CALIFORNIA INSTITUTE OF TECHNOLOGY
Laser Interferometer Gravitational Wave Observatory (LIGO) Project

To/Mail Code: Dist. via M. Coles
From/Mail Code: A. Sibley
Phone/FAX: 395-3046/304-9834
Refer to: LIGO-E950098-A-F
Date: December 19, 1995

Subject: OPERATIONS SUPPORT BUILDING (OSB) REQUIREMENTS

CONTROL ROOM P 1 of

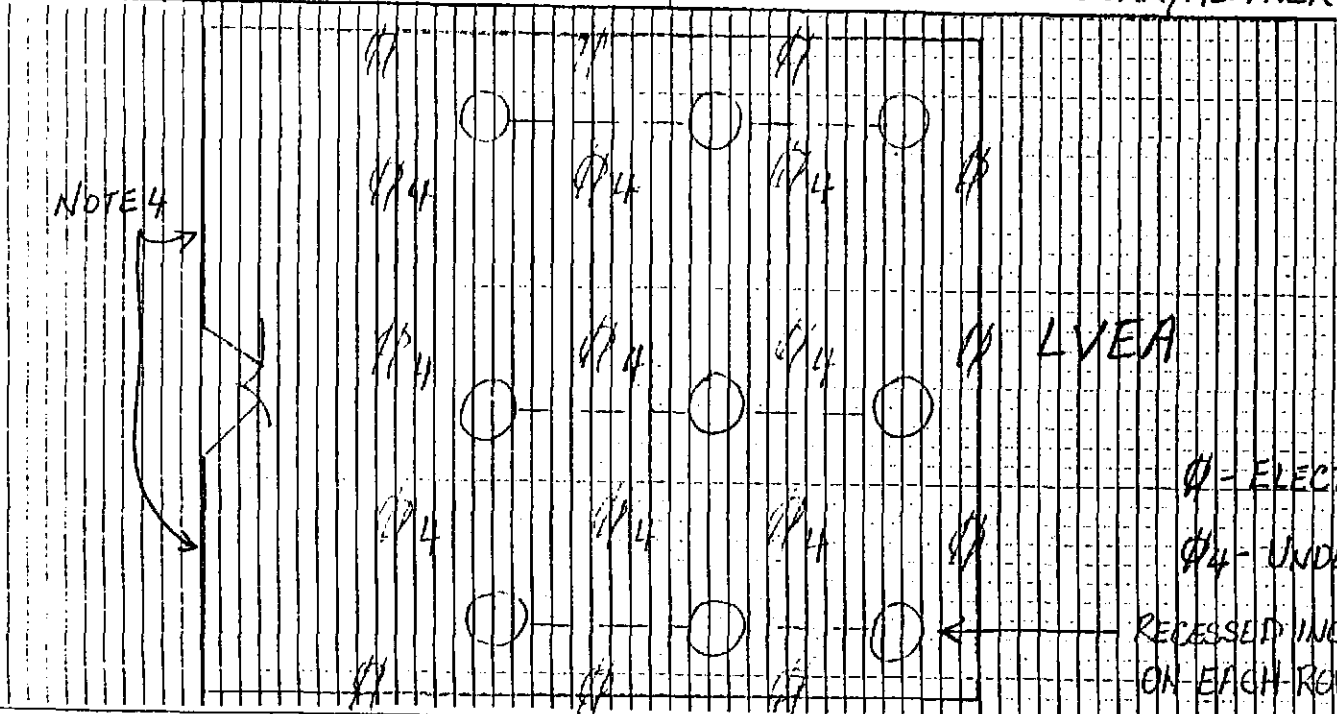
CDS has requested an increase in area for this room. A glass wall would be placed on the wall adjacent to the hall for visitor viewing of the control room during operations with minimal disruptions. Also, raised floor connecting LVEA mass storage. The Control room lighting would be fluorescent lights with on/off switches and incandescent spot lights in three (3) equally spaced rows with dimmer control on each row. See Sheet.

1) Lighting in Control room: We want both flourescent (for use during installati on/ non-operating times), which can be switched on/off and incandescent spots w/dimm er controls to reduce the light levels during operations.

2) The power breaker panels for the electronics repair area and the control room should provide for lock outs (for lock and tag maintenance procedures). I don't know if anyone has thought about this, but it should be done for all breaker panels in the LVEA and other buildings as well.

- 1.) ALL POWER BREAKERS TO PROVIDE LOCKOUT AND TAG
- 2.) UNDER FLOOR CONNECTIONS TO ADJACENT ROOMS. MIN. 3 FEET TO EACH ROOM.
- 3.) WALLS SHOULD BE BARE AND ARE TO BE USED AS VIDEO WALLS.
- 4.) GLASS WALL AT ENTRANCE
- 5.) PROVIDE 2 EACH 6" Ø CONDUITS TO AREA TBD IN LVEA
- 6.) PROVIDE 2 EACH 6" Ø CONDUITS TO VAC. MECH. AREA TBD.
- 7.) CDS WILL PROVIDE LAYOUT FOR CONTROL CONSOLES AND SPOT LIGHT LOCATIONS.

GENERAL COMPUTING P 1 of 1

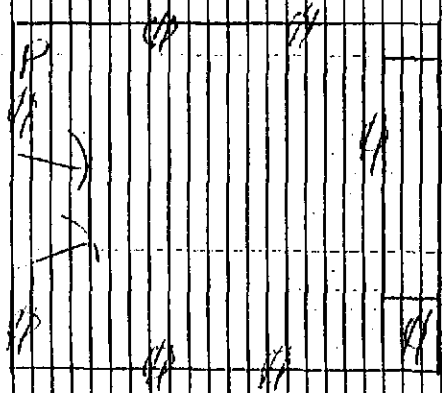
This room was left out of OSB floor plan. Proposed new location (by CDS) is in the utility room area. This area must be environmentally controlled and the walls are bare for General Computing installation of patch boards. General Computing network: 1) Four (4) each Category 5, network connections in each office wiring back to 110 patch board in General Computing Room, 2) One (1) each Category 5 network connection every ten (10) feet in all shops, common areas with wires

back to General Computing Room. 3) Minimum of two (2) each 4 plex Category 5 connections in Conference Room with wiring back to General Computing Room. 4) Minimum of ten (10) Category 5 connections from General Computing Room to Mass Storage and Tape Room. Then coil cable up under floor minimum of twenty-five (25) feet coil. See requirement sheet for utility detail. *Note That telephone lines/routers/patch panels should be collocated in This room. (AL note).*

- 1) ALL OFFICE 10BASET CONNECTIONS ARE ROUTED INTO THIS ROOM FOR PUNCH DOWNS.
- 2) NORMAL OCCUPANCY - 0
- 3) ROOM TO BE USED FOR NETWORKING & SERVICES FOR OFFICES & GENERAL COMPUTING AT SITE.

ELECT. TEST & MAINT. P 1 of 1

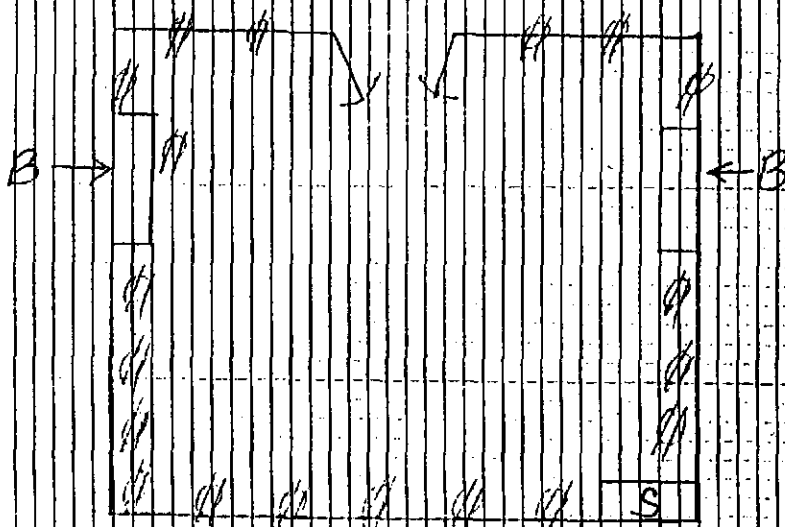
Only unique requirement is the capability to attach cable tray to ceiling. Electric utility in this area should be plentiful (120V, and 208V, 3 phase) and would be lock and tag.

- 1.) NORMAL OCCUPANCY - 5
- 2.) CIRCUIT BREAKER PANELS
W/ 200 AMPS SERVICE W/ 10
BREAKERS NOT FOR WALL
OUTLETS.
- 3.) PROVISIONS FOR FUTURE
CABLE TRAY HUNG FROM
10' CEILINGS.
- 4.) SINK IN CORNER.

AREA
COMPUTER USERS P ___ of ___

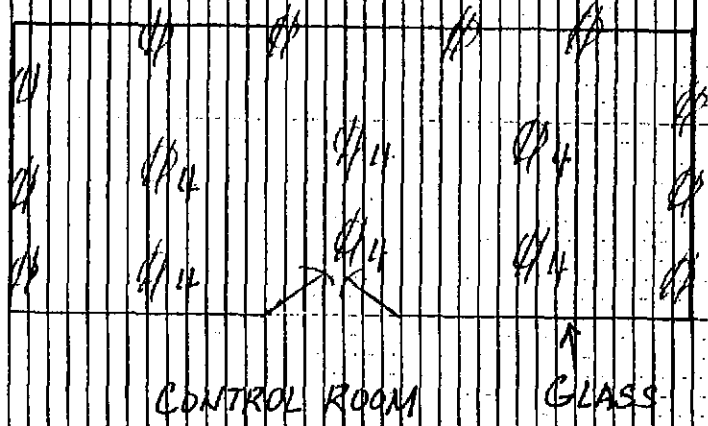
A raise^d floor with minimum of three (3) feet wide (or six (6) square feet) connection to control room. CDS requests a glass wall for this room. Also, an increase in the width of the area between the Control Room and this area will help in accommodating visitors.

NOTES
 1) NORMAL OCCUPANCY - 6
 2) UNDER FLOOR CONNECTIONS TO ADJACENT CONTROL ROOM.
 3) GLASS WALL AT ENTRANCE.

CLEANING AREA P. 1 of 1

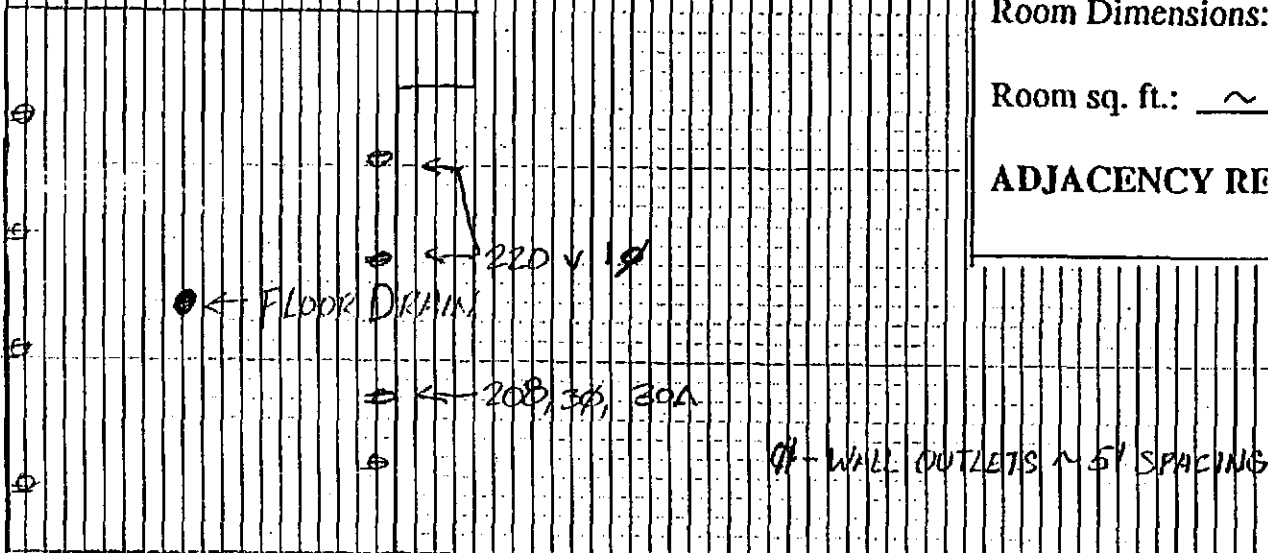
A source of water should be provided in this area along with a sink and floor drain. Electric utilities should be standard 110/220V, 208V, 3 phase, 30A, distribution.

VACUUM PREP

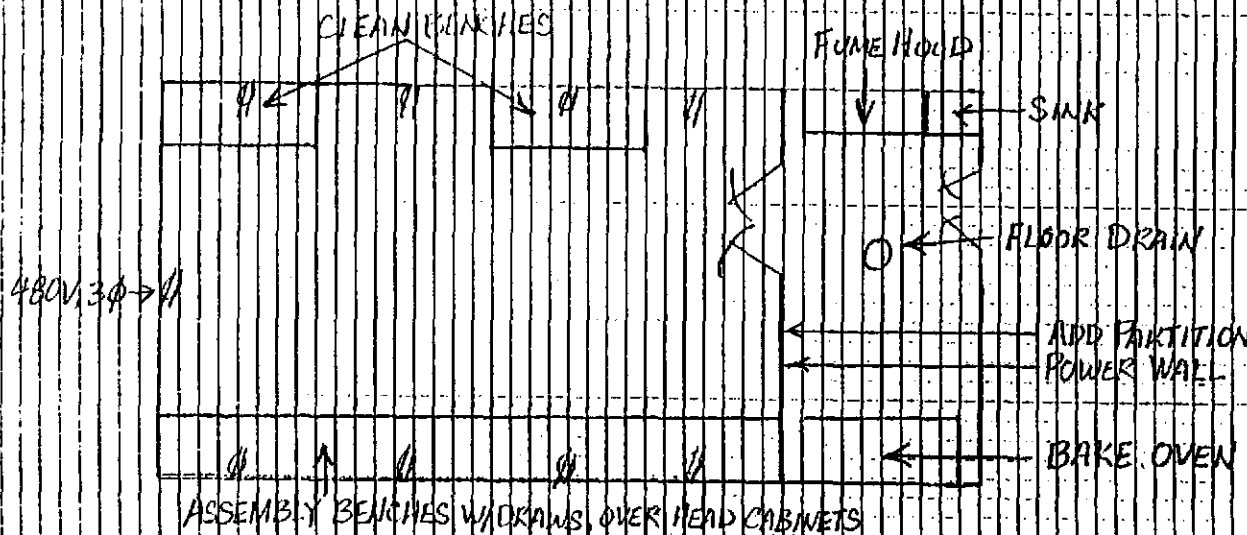
Proposed partition is added in this area. The reason for that is a fume hood (800 cfm) is not easily compatible with a clean area. Additionally a floor drain and sink in the hood are required. Automatic control of fume hood flow should be provided. No compressed air.

- 1) ADD PARTITION
- 2) FUME HOOD 800 CFM, REVD AUTO CONTROL ON HOOD.
- 3) SINK IN FUME HOOD.

OPTICAL LAB

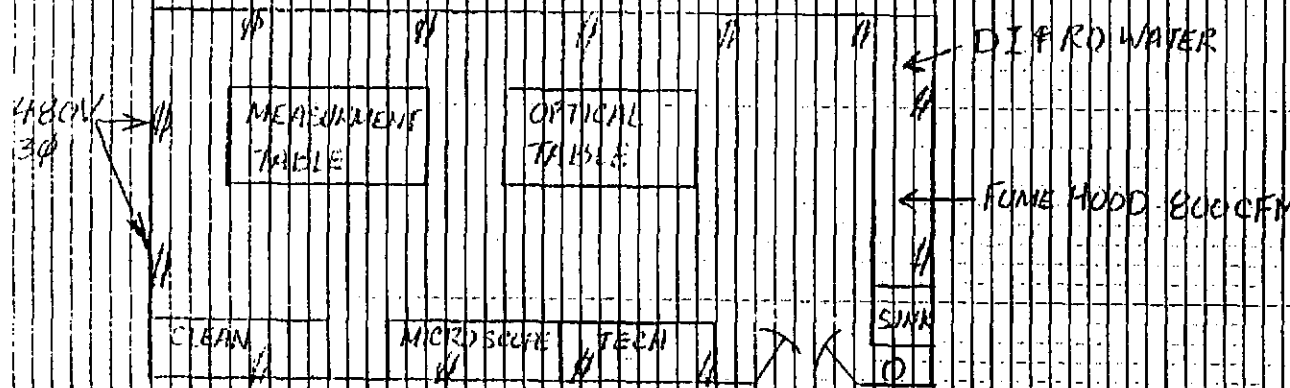
Other than wall finishes and deionized water (DI) plant this is just an open area to be populated with work/clean benches. A future source of 15M ohms DI/RO filtered water should be accommodated by providing a floor drain and a sink which would provide make up water. No compressed air.

MECH. SHOP

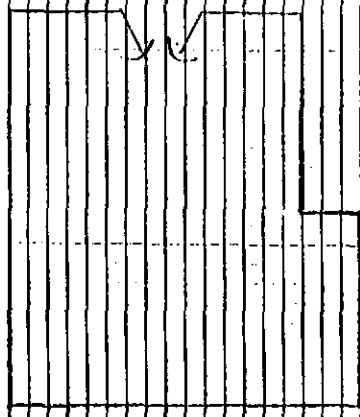
Sink and floor drains should be provided. Only small machine tools would be allowed in this area, for cleanliness consideration of Vacuum Prep, and Optical Lab (only small amounts of hydrocarbons). No compressed air.

AREA MASS STORAGE & TAPE P 1 of 2

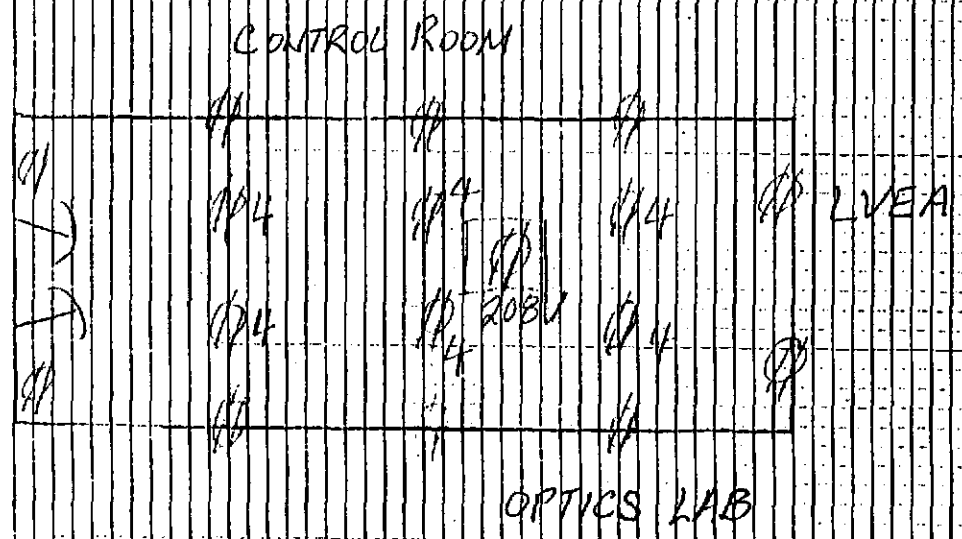
Significant highlights of this area are the raised flooring with connection to control room. CDS does not require forced air in this space, specific requirement for utilities are detailed on sheet 1 of 2. CDS would like to have all computer, disk and tape drives in this area along with Tape Storage. CDS does not require fire resistant storage.

NOTES
 1.) NORMAL OCCURPANCY - 0
 2.) UNDER FLOOR CONNECTIONS TO ADJACENT CONTROL ROOM. MIN. 3 FEET WIDE.
